# SS 306 TBB HDX DEF Header Service Replacement Additional Parts

TBB HDX

DEF Header Failure replacement

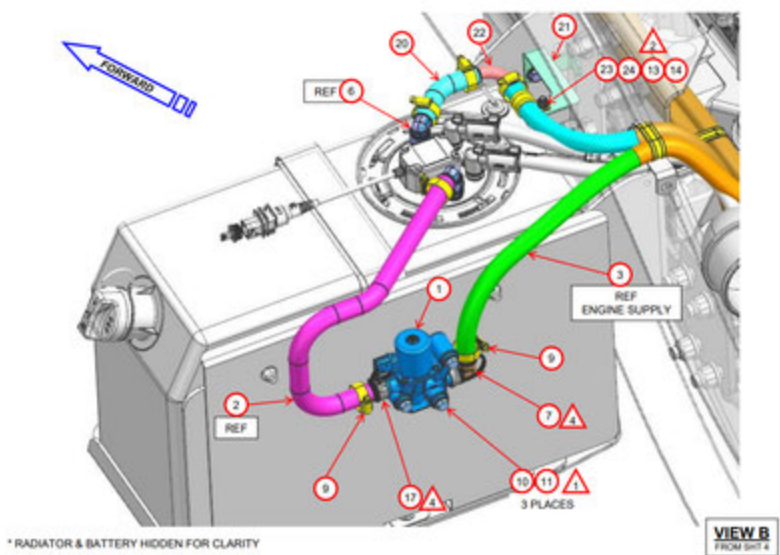
There are no longer SSI DEF Header replacement parts. If the vehicle came equipped with an SSI DEF Header, and that SSI DEF Header has failed, then a replacement KUS DEF Header 04 37614 000 must be used. The replacement requires some additional parts and re routing of DEF Pump Supply Coolant line. Refer below for how item 20 and 22 is routed.

Pump Supply Coolant line. Refer below item 20 and 22 is installed.

TBB 248554 Formed hose Silicone

TBB 248552 Formed hose BS 5/8 ID

TBB 248782 Pipe

Hose Clamps TBB 61190163 (4)
